RECEIPT DATE: 6/18/15 **ONSITE SEWAGE DISPOSAL SYSTEM** P 556489
 APPROVAL DATE: 7/21/15 RW **PERMIT: CONSTRUCTION** A _____
 PROPERTY ADDRESS: 815 Iron Rail Court
 SUBDIVISION: Morgan Station LOT: 8 TAX ID: 04-347439
 CONTRACTOR: Fogle's Septic Clean Inc. EMAIL: kevin@foglesinc.com
 CONTRACTOR ADDRESS: 580 Obrecht Road, Sykesville, MD 21784 PHONE: 410-795-5670

RE: BAT Site Plan; Morgan Station Lot 8 (815 Iron Rail Court; Clarke residence)

RE: BAT Site Plan comments; Morgan Station Lot 8 (815 Iron Rail Court; Clarke residence)

MORGAN STATION
 LOT 8
 SITE PLAN FOR BAT INSTALLATION

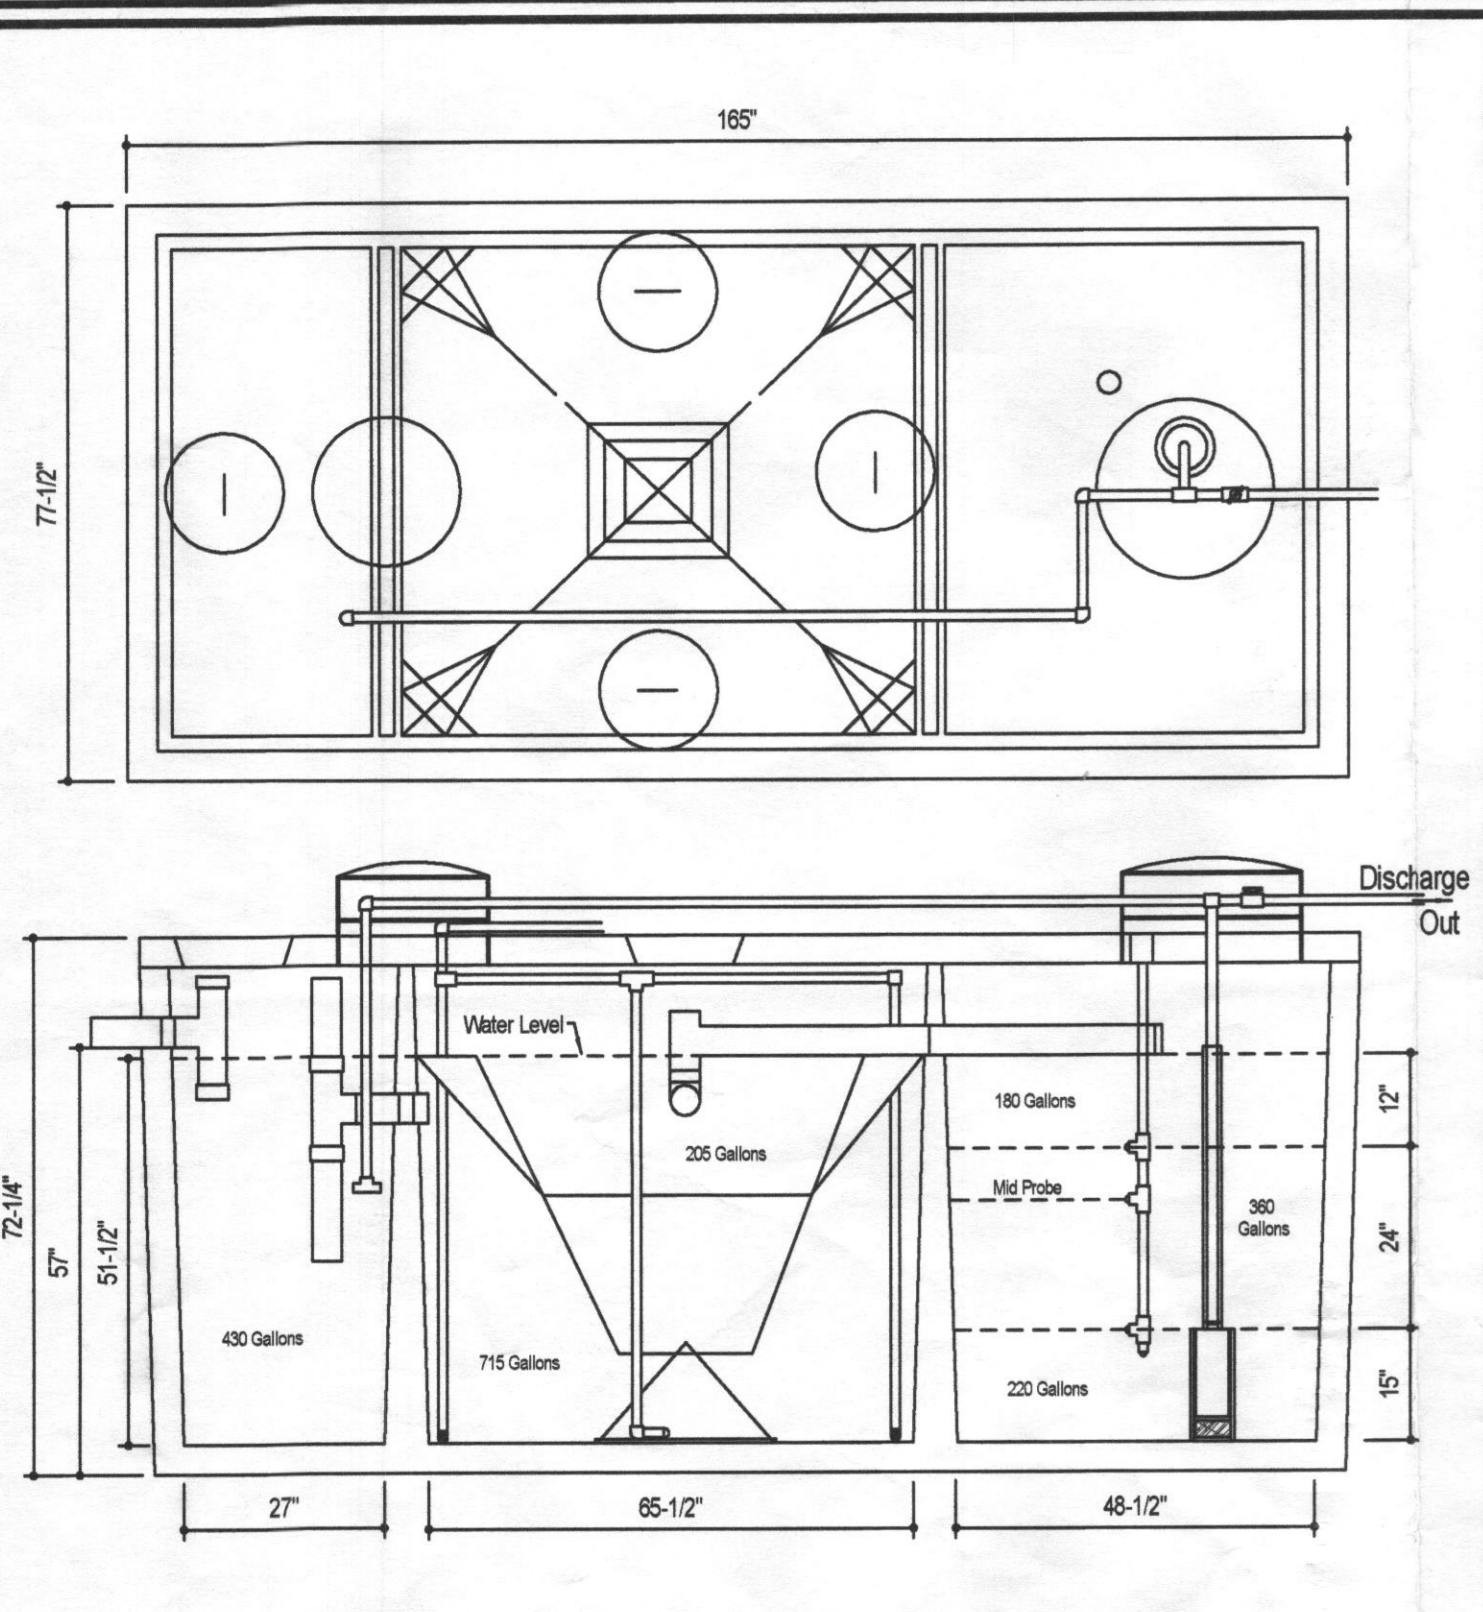
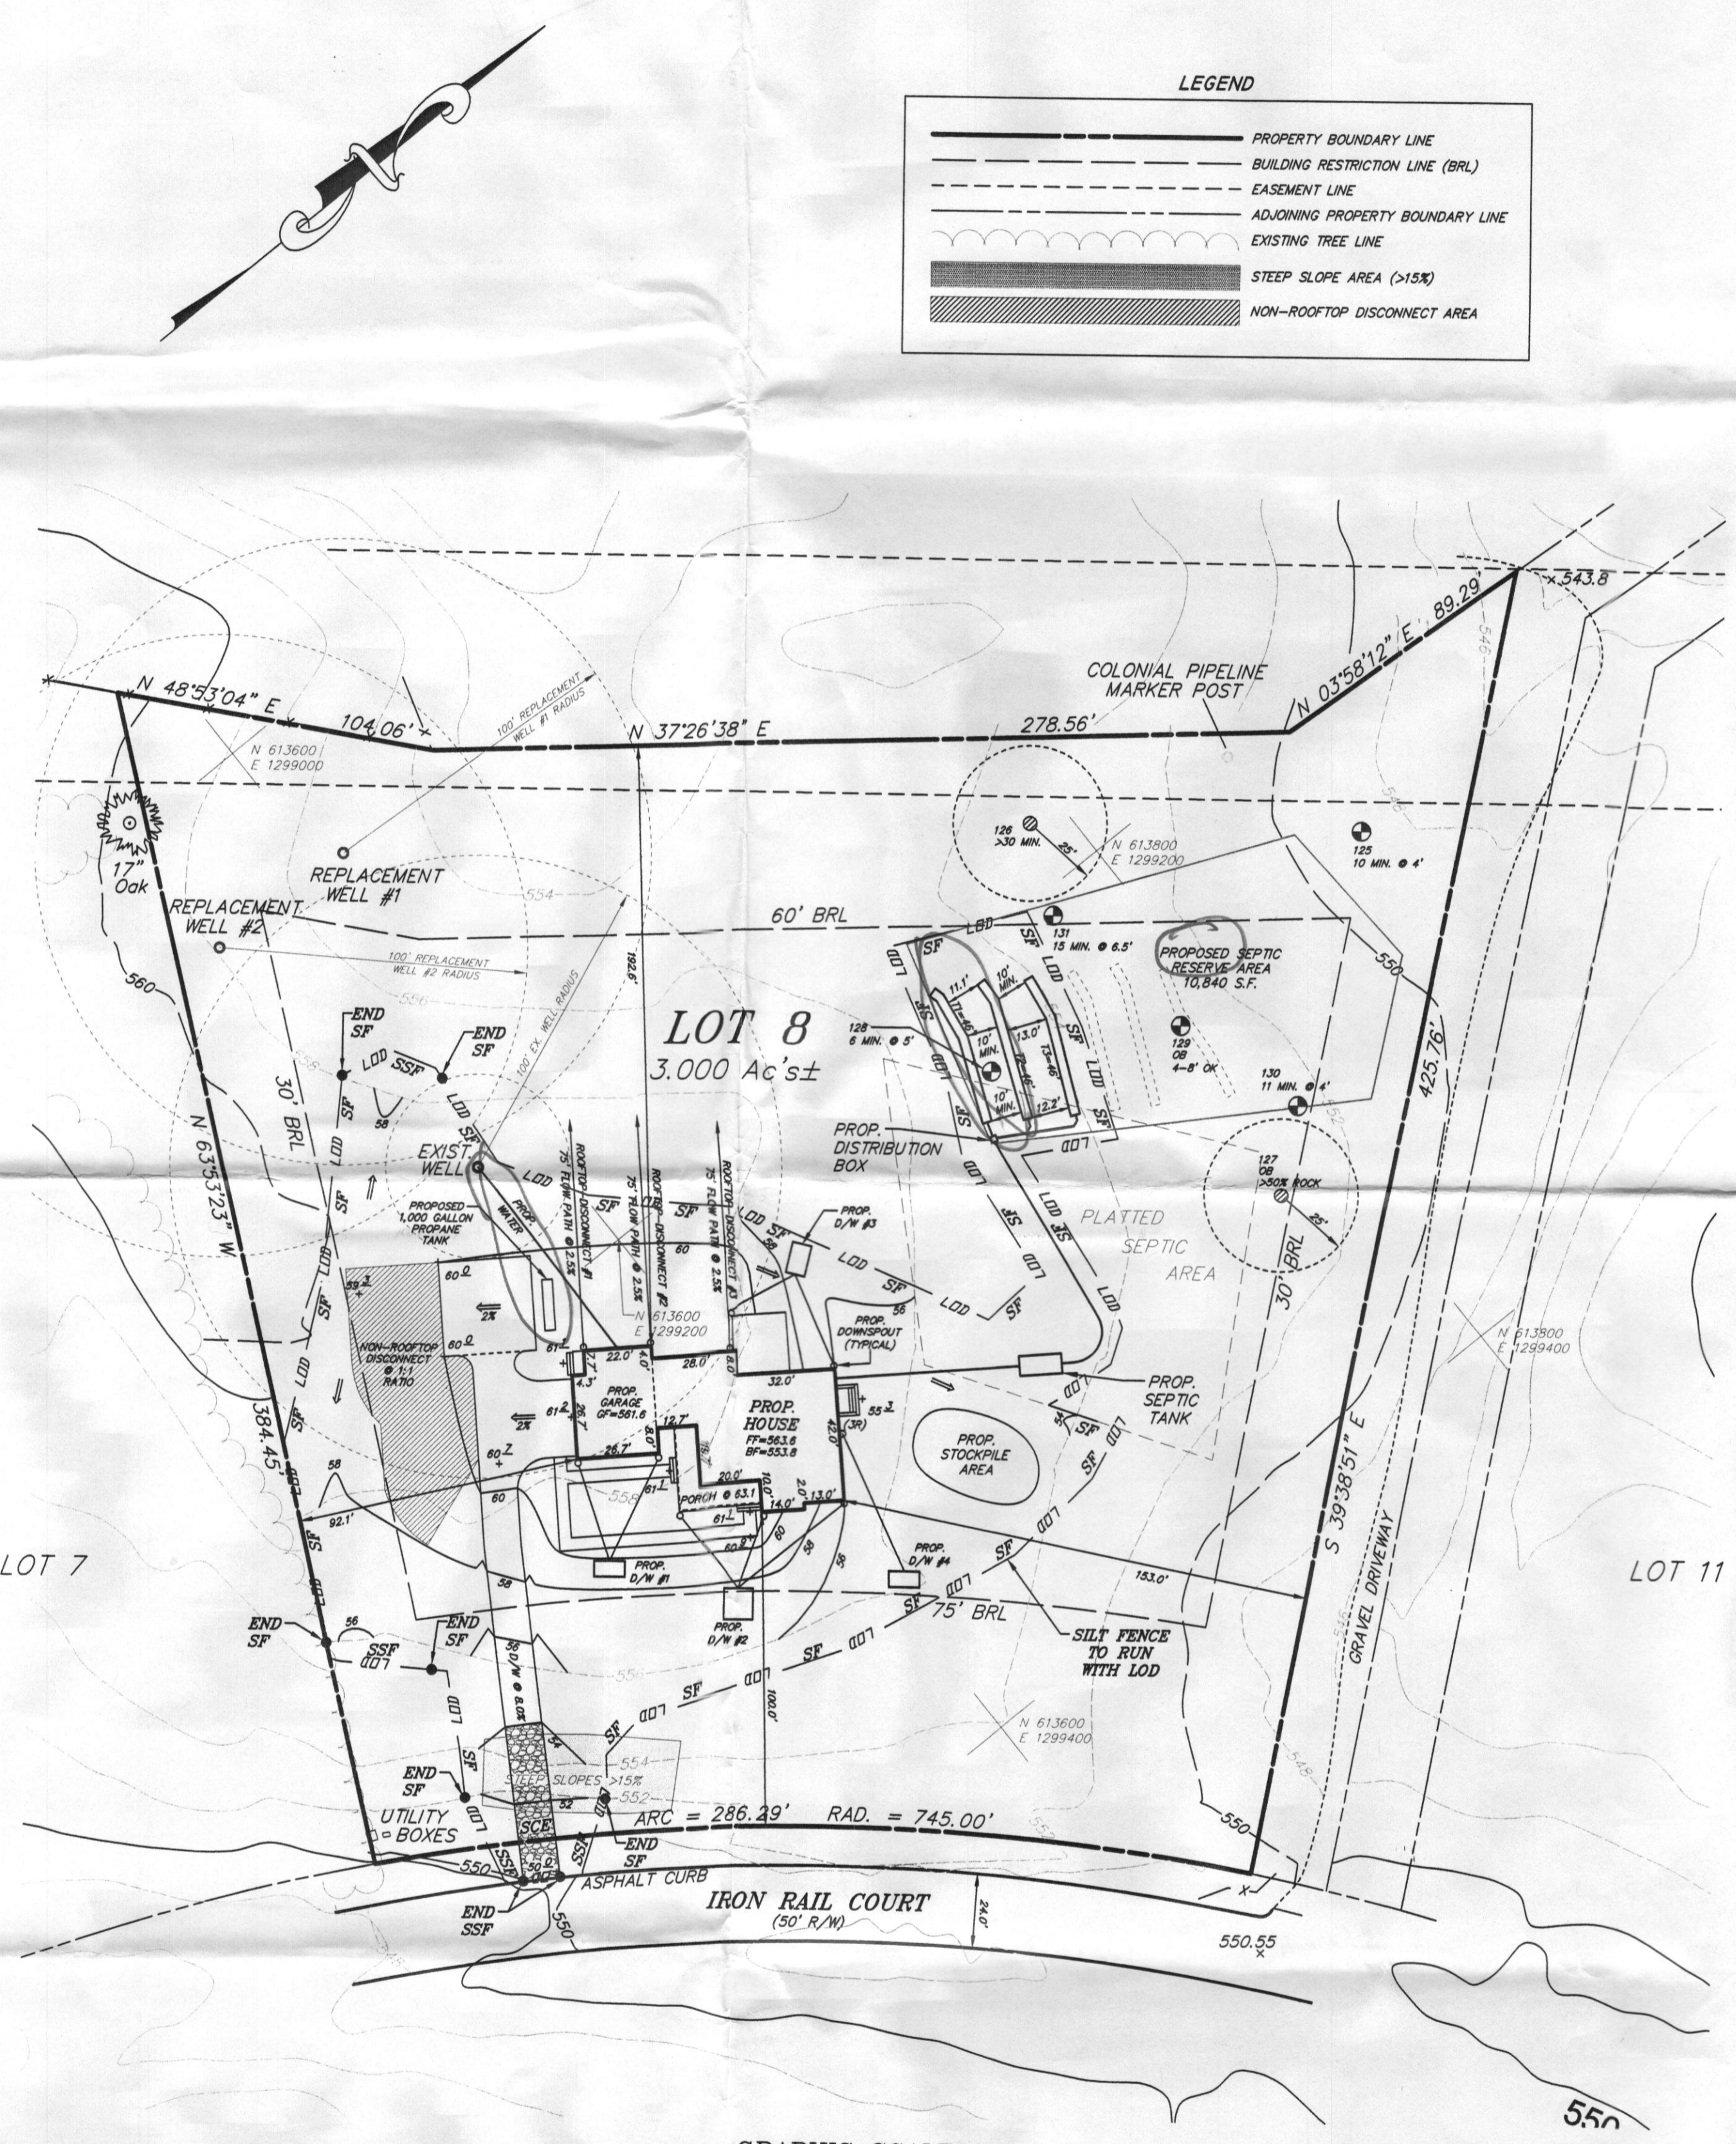
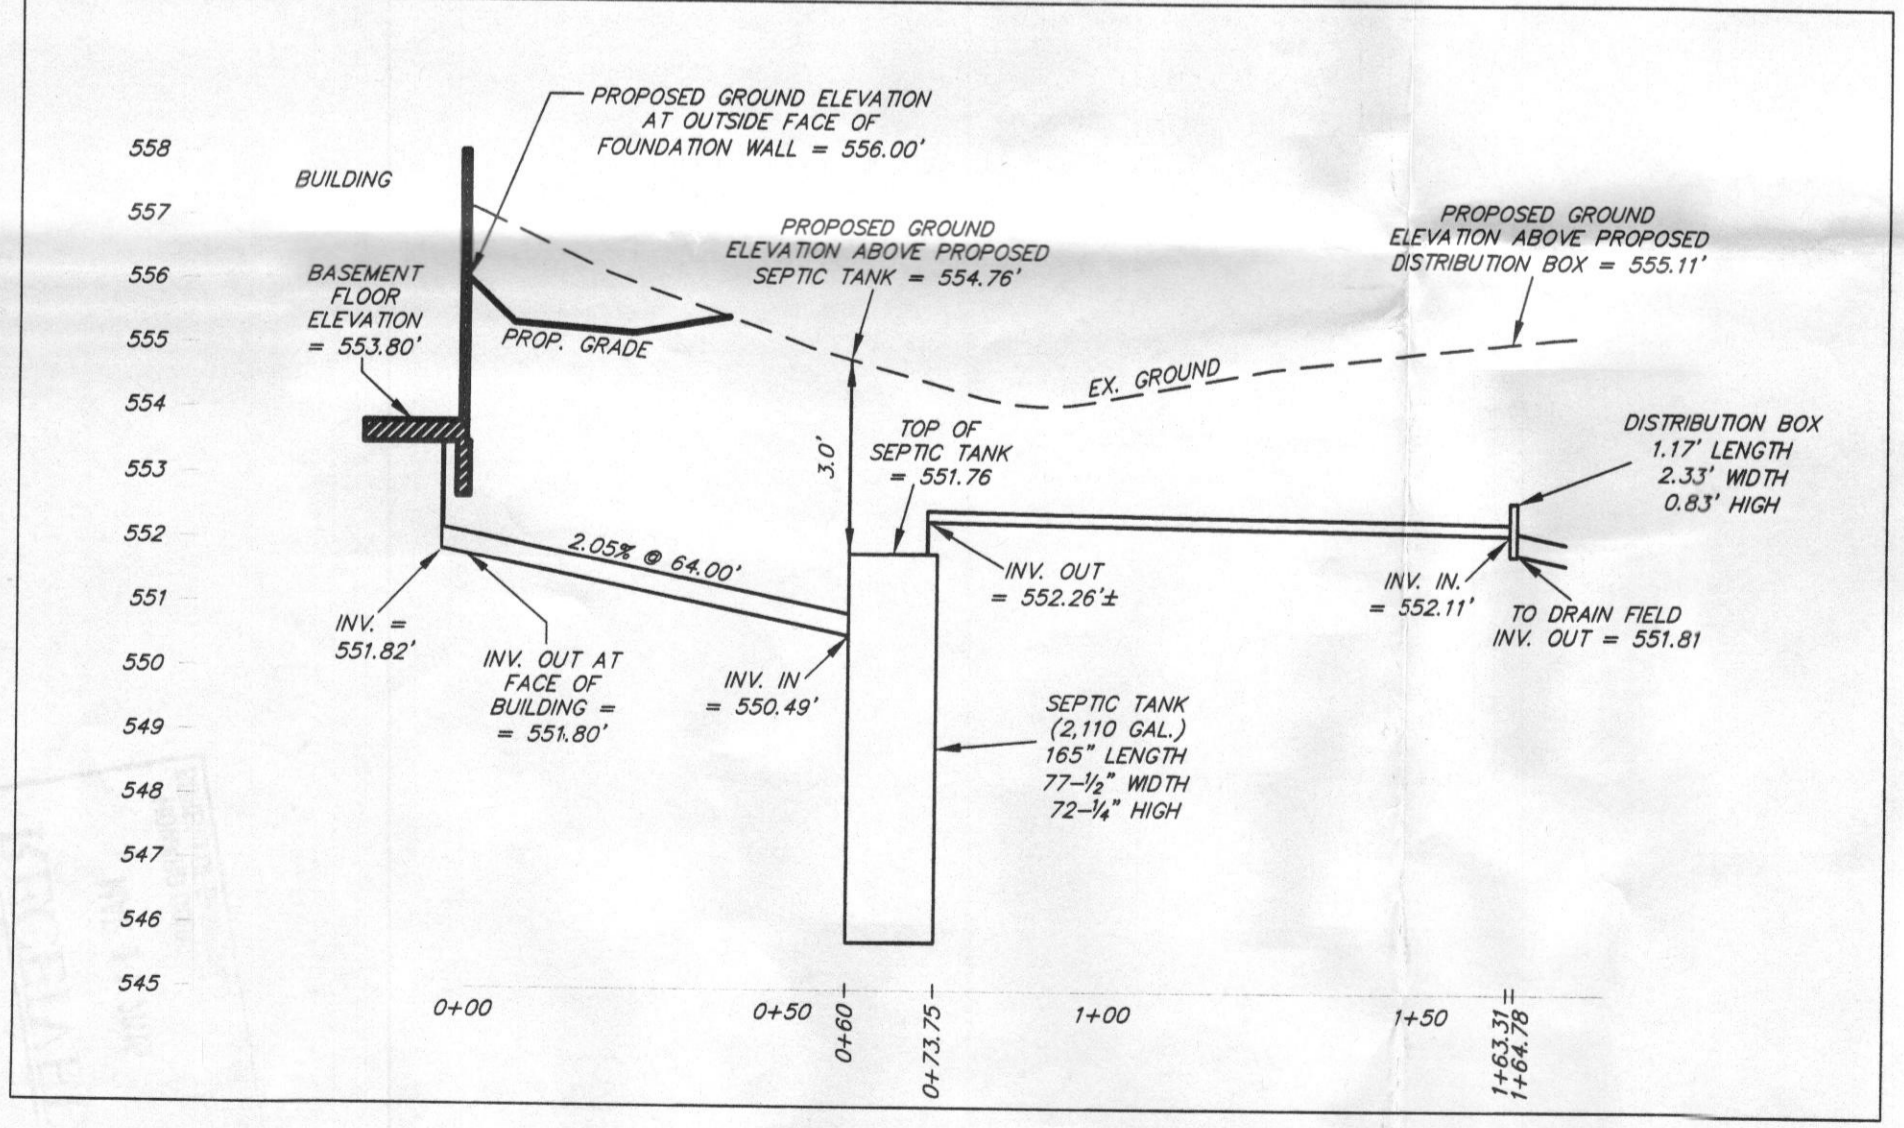
1. The LP tank is illustrated within 50 feet of the existing well which is a condition that I cannot approve. Any part of the LP tank must be at least 50 feet from the well (if it is nearly level or at a lower elevation).

2. There are two errors in TRENCH DESIGN:
 - a. The coefficient 0.55 utilized to calculate trench length is incorrect for the amount of effective sidewall available in the 8-foot deep trench. The 4 feet of trench under the pipe elevation is all effective sidewall. Therefore, 0.42 is the value of the coefficient by which the trench length is reduced.

- b. Correct the calculated total trench length accordingly.
 - c. The 10-foot minimum spacing between trenches is incorrect. There is 4 feet of effective sidewall in the 3-foot wide trenches. Therefore, the minimum spacing for these trenches is $(2 \times 4\text{ft.}) + 3\text{ft.} = \underline{11\text{feet}}$.

3. Correct the number and length of trenches, and the spacing between trenches for the respective systems in the septic reserve area.
4. Remove the term "PROPOSED" from the septic reserve area label and replace it with the term 'APPROVED'.

1. The LP tank has been moved so that it is 52' from the well at its closest point, as shown on the attached revised plan.
2. The following has been updated:
 - a. The coefficient has been updated, and a new minimum trench length of 105' has been calculated.
 - b. Corrected
 - c. Spacing has been updated to 11' minimum.
3. Two 53' long trenches are proposed, and the spacing is shown as 11' minimum.
4. Septic Reserve has been changed to "APPROVED"
